**RE: Cripple Creek & Victor Mining, Co. Cresson Project M-1980-244;
Additional Review Comments for Quality Assurance Monitoring & Test Results Final Report for
Squaw Gulch VLF Phase 1 (9,550 Bench to Completed Areas Outlined on Figure 2)**

Figure 1 Barren Pipe Tie-In

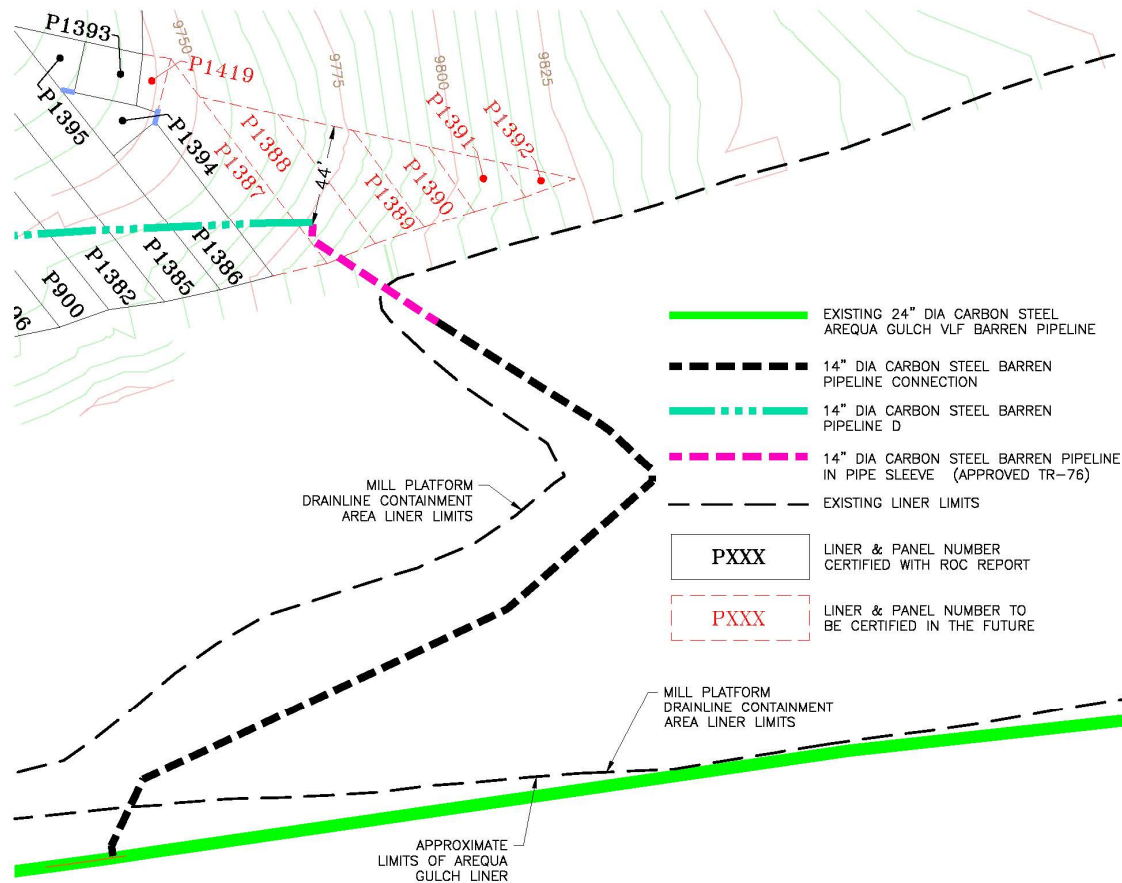
The Record of Construction (ROC) report submitted to DRMS in January 2016 does not include geomembrane Panels P1387 through P1392 or Panel P1419, however the 14-inch-diameter barren solution pipe crosses over two of these panels. These geomembrane panels were accepted for drain cover fill (DCF) placement on October 26, 2015 (approval located in ROC report Appendix J.7) and was also shown on the geomembrane acceptance map included with the weekly reports, week ending October 31, 2015 located in Appendix D of the ROC. Amec Foster Wheeler did not include these geomembrane panels in the ROC report because while drain cover fill material was placed over the panels, a buffer must remain to allow for 2016 construction and geomembrane tie-in thus not allowing the entire panel to be part of the ROC report.

There are two geomembrane panels where the 14-inch-diameter barren pipe is located, but the geomembrane below the pipe has been installed according to the Technical Specifications and under quality assurance supervision and provides dual containment for the barren pipe. Any barren solution will flow down gradient on geomembrane in the unlikely event that any leaks occur in the pipeline in this vicinity. The distance from the center of the barren pipe to the nearest edge of the temporary anchor trench is approximately 44 feet, the minimum required distance is 15 feet from the barren line to edge of geomembrane. Figure 1 shows the as-constructed location of the barren pipe tie-in. The magenta line is the pipe-in-pipe dual containment location which was approved with TR-76 and connects to the barren pipe (aqua line) on the geomembrane lined area certified in the ROC report. The black line is the barren pipeline connection and is located on the certified geomembrane of the Mill Platform Drainline Containment Area geomembrane and on the

certified geomembrane of the Arequa Gulch VLF. At no point does the barren solution pipeline not have a form of dual containment.
